Staff Report

To: Salt Lake City Historic Landmark Commission
From: Aaron Barlow, AICP, Principal Planner
801-535-6182 or aaron.barlow@slcgov.com
Date: September 1, 2022
Re: Petition PLNHLC2022-00297 – New Construction at 158 North State Street

NEW CONSTRUCTION IN A HISTORIC DISTRICT

FRONT ELEVATION

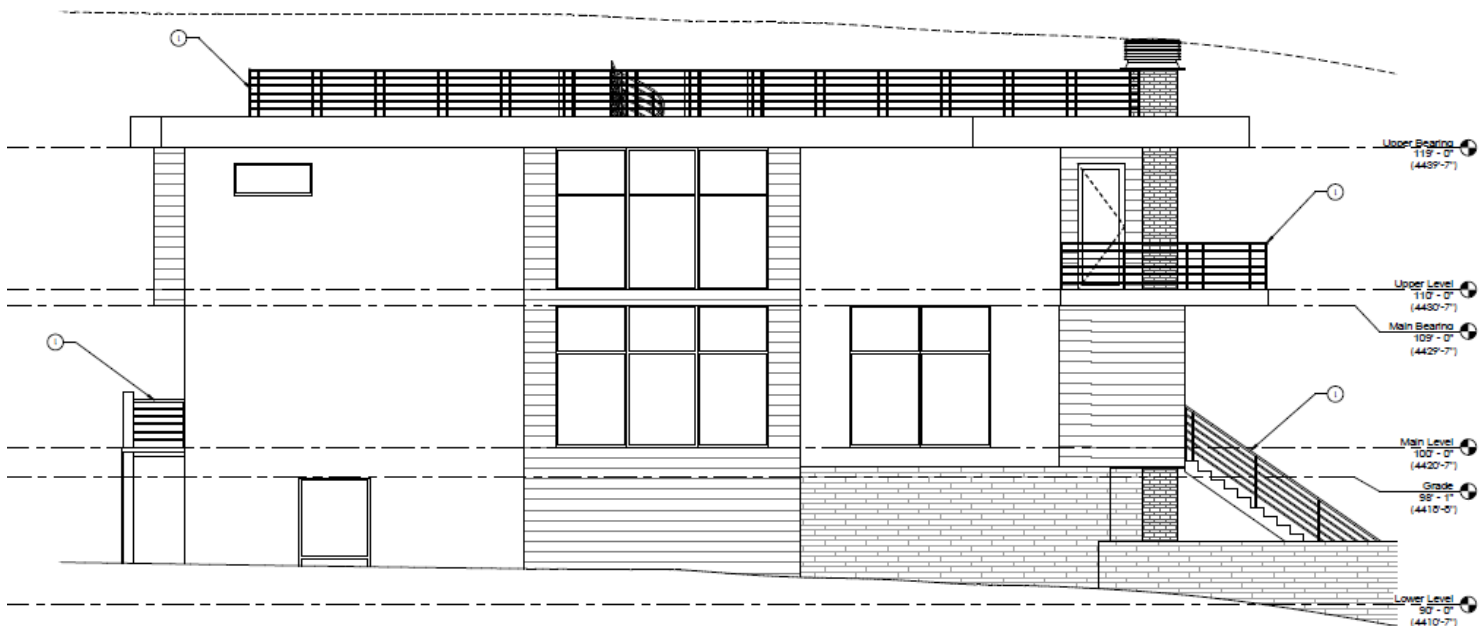
A wide chimney of dark brick sits near the middle of the front elevation of the proposed house, framed by floor-to-ceiling picture windows on the top two stories. Earlier iterations of the proposal had wider windows. Staff recommended that they be broken up to reflect the vertical emphasis of the existing building’s windows. Cedar siding fills up the remainder of the space on the elevation’s two upper stories. Except for the chimney and porch stairs, the base of the structure will be wrapped in white brick. A balcony wraps the second story of the building and another sits on the top of the building. Both will have railings with a horizontal design made of the 2-inch-thick tubing mentioned earlier.

LEFT ELEVATION

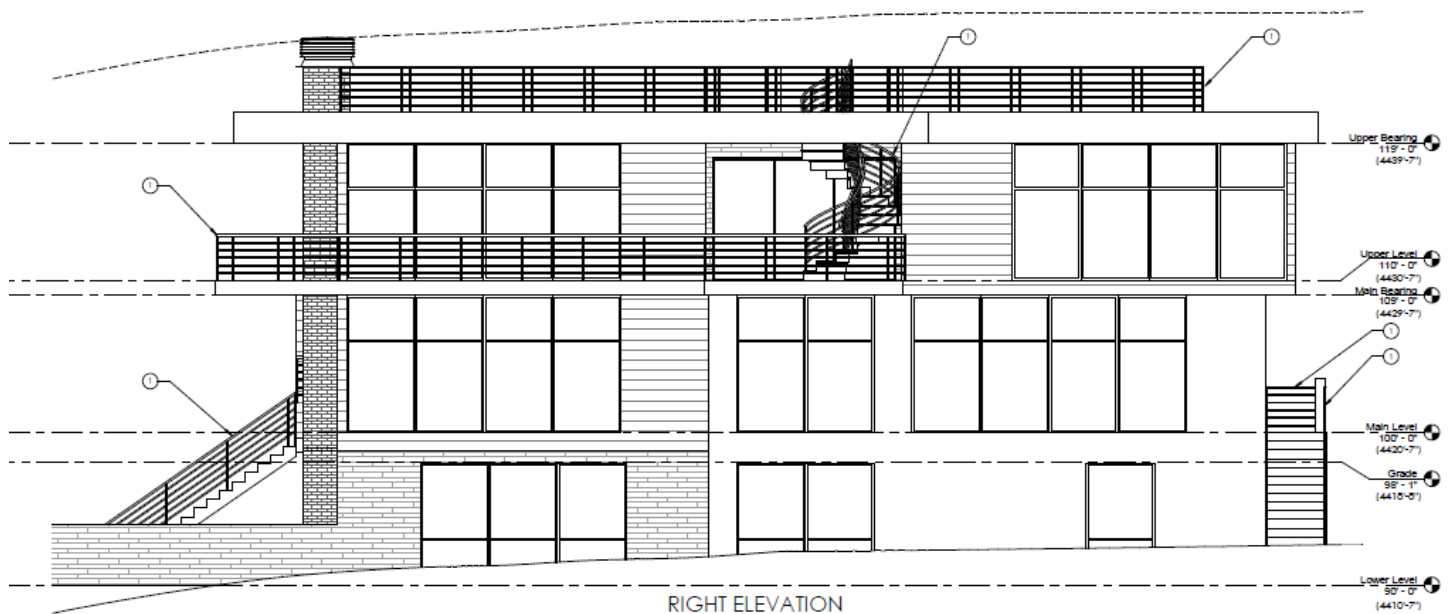
The side elevation to the east (facing the existing house) continues the pattern established by the front (white brick, cedar siding, and picture windows), but adds white stucco as you move towards the back of the building. The west elevation, which faces the park, also has a similar pattern, but with nearly a wall of windows. The applicants stated that because it is the “side of the house that people will see the most,” they wanted to “build a visually stunning house that has a lot of glass and character.” The house’s rear elevation will also have floor-to-ceiling picture windows and cedar siding on the second story. However, it will primarily be wrapped in white stucco.

Current Proposal

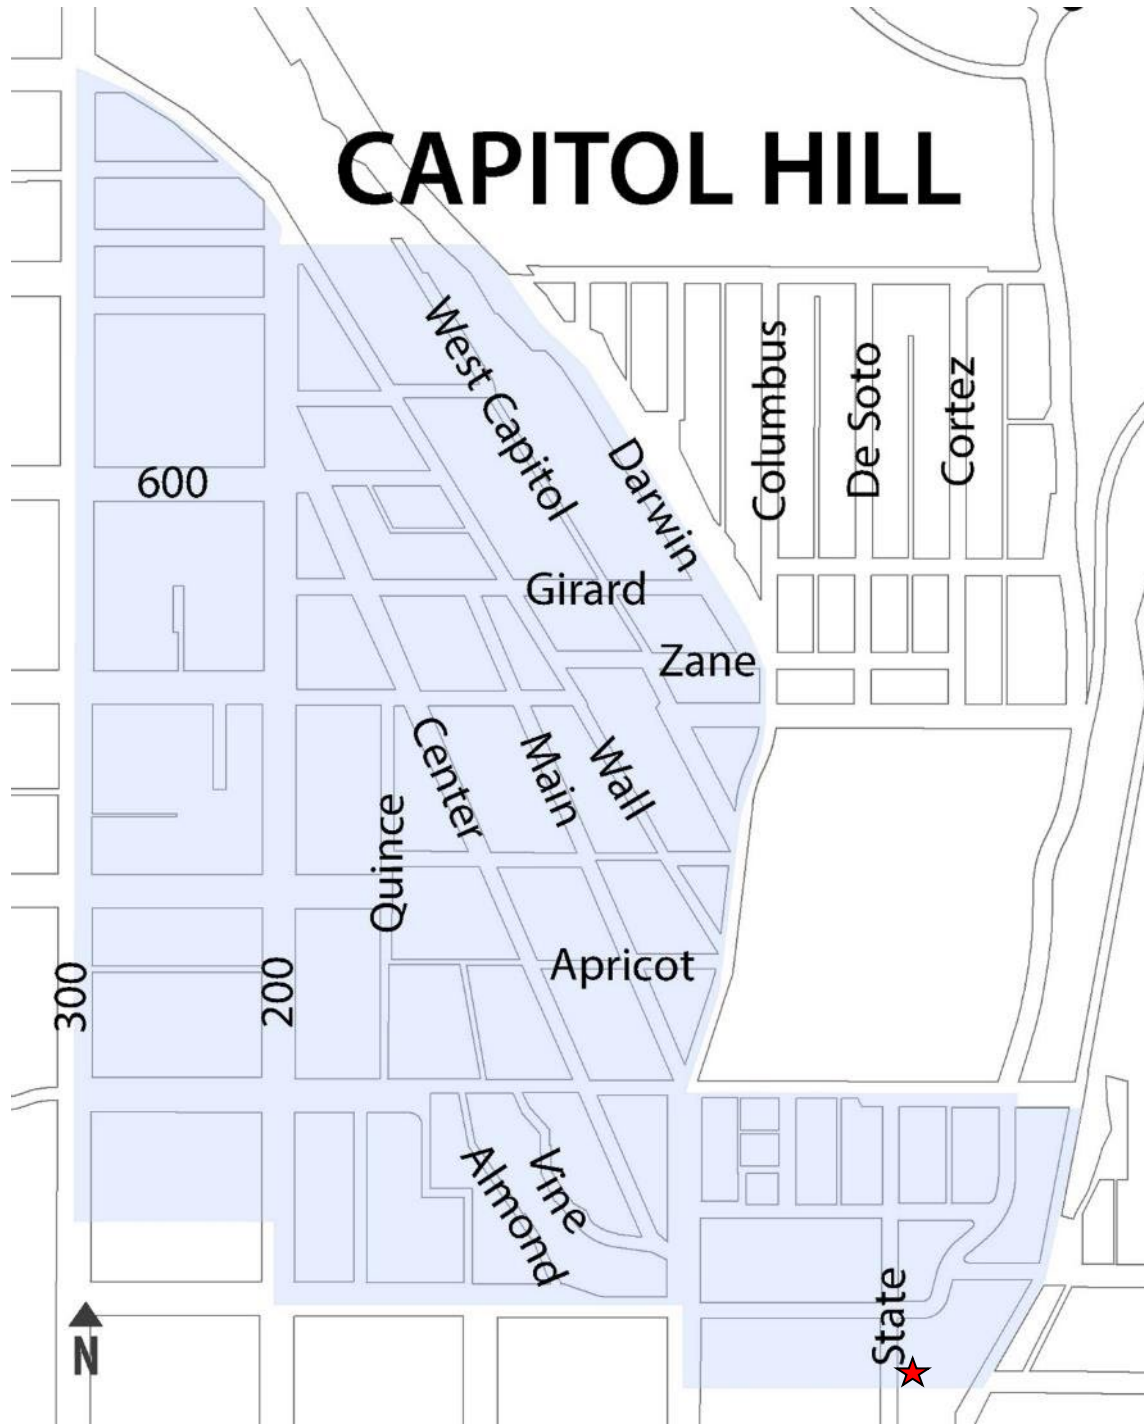
The proposed two-family dwelling complies with the adopted standards in 21A.34.020.H and Chapter 12: New Construction in the Residential Design Guidelines. The applicant worked with staff to make numerous modifications to the initial proposal. Renderings of the initial submittal and the current proposal are below for comparison. Changes made by the applicant include:

- Replacing the cantilevered basement with a bulkier base that reflects the scale of existing houses in the neighborhood
- Dividing the picture windows to add a stronger vertical emphasis to the facades visible from the public right of way
- Removal of a garage on the front of the house
- Reducing the size of the front door to better match the scale of surrounding properties

SITE PLAN

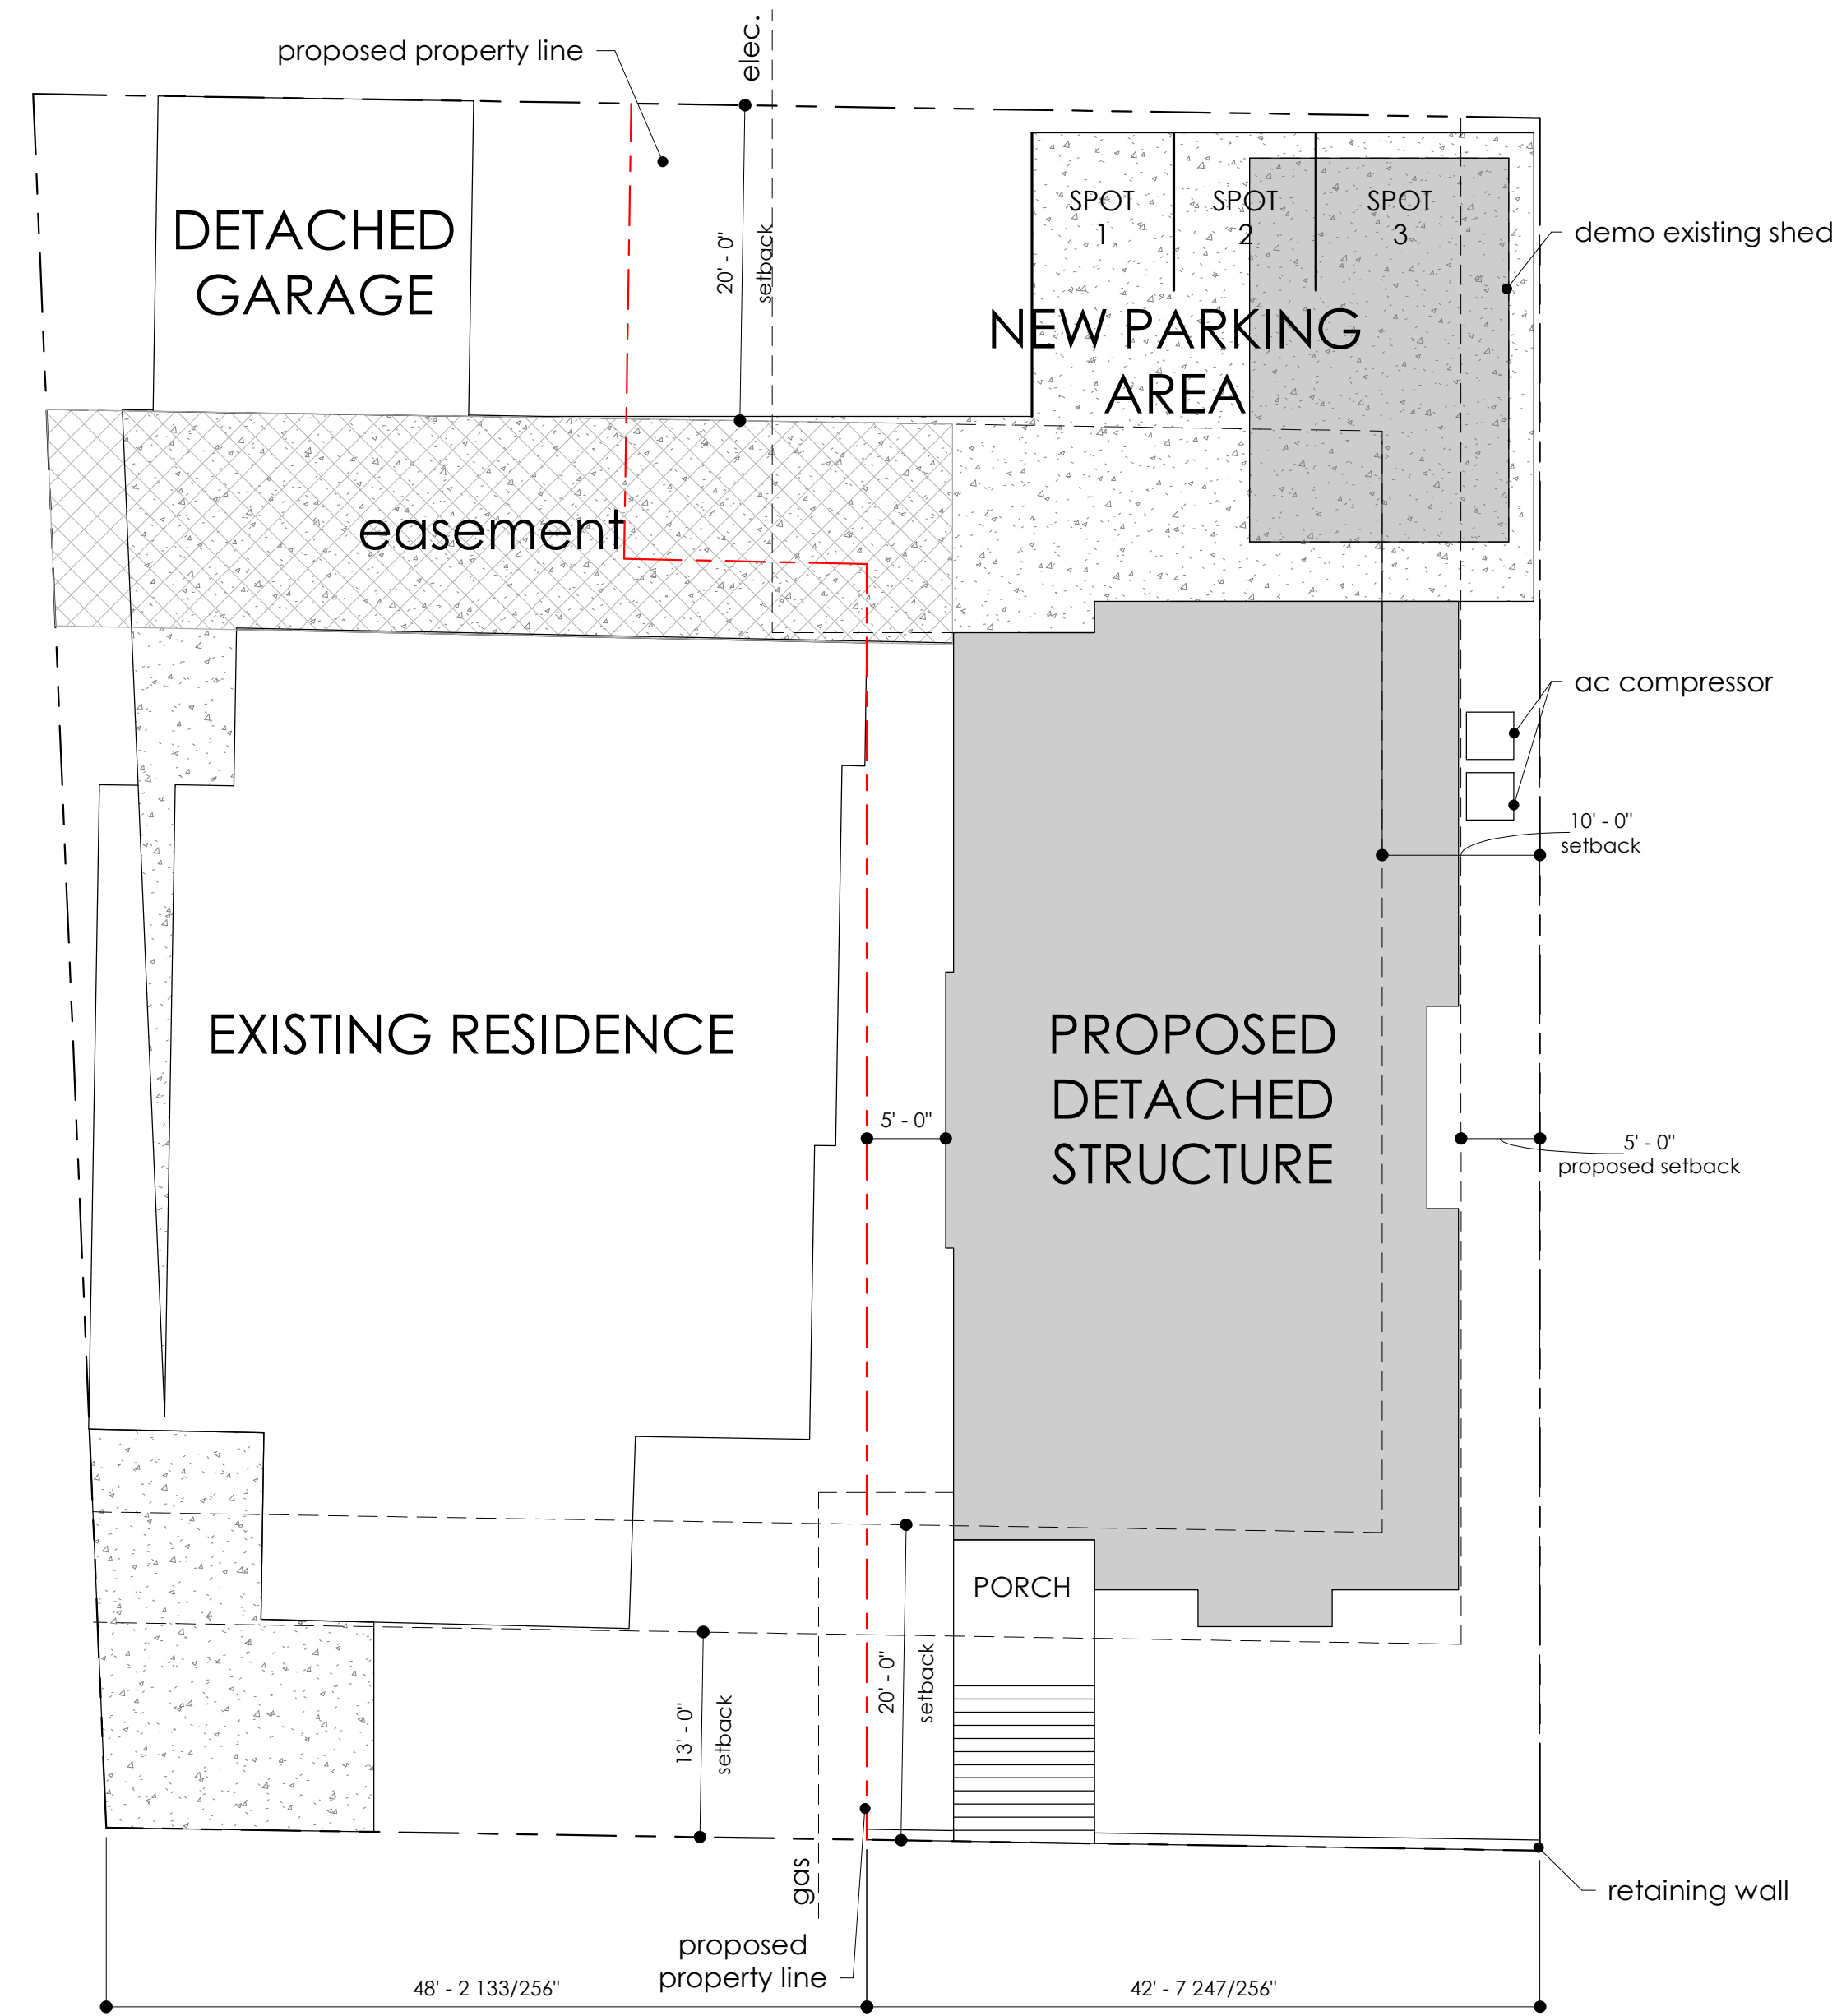
- The HVAC equipment near the southwest corner of the house shall be screened from view.
- Approval of all final design details, including specific direction expressed by the Commission, shall be delegated to Planning Staff.

<p>2. Site Access, Parking, And Services:</p> <p>a. Site Access: The design of the project allows for site access that is similar, in form and function, with patterns common in the historic context and the block face.</p> <p>(1) Pedestrian: Safe pedestrian access is provided through architecturally highlighted entrances and walkways, consistent with patterns common in the historic context and the block face.</p> <p>(2) Vehicular: Vehicular access is located in the least obtrusive manner possible. Where possible, garage doors and parking should be located to the rear or to the side of the building.</p> <p>b. Site And Building Services And Utilities: Utilities and site/building services (such as HVAC systems, venting fans, and dumpsters) are located such that they are to the rear of the building or on the roof and screened from public spaces and public properties.</p>	<p>The site access, parking, and related services are located such that they are compatible with the neighborhood.</p> <p>a. Access to the site is similar to other properties in the neighborhood.</p> <p>(1) Pedestrian access to the main entrance will be provided from a pathway from a new sidewalk onto State Street.</p> <p>(2) Vehicular access will be provided through an existing shared driveway that straddles the north property line of the building. Shared driveways to parking behind houses is common in this neighborhood.</p> <p>b. The proposed a/c condensers will be located near the rear of the proposed house. <i>Staff recommends that they be screened from the adjacent park as a condition of approval.</i></p>	<p>Complies with recommended condition</p>
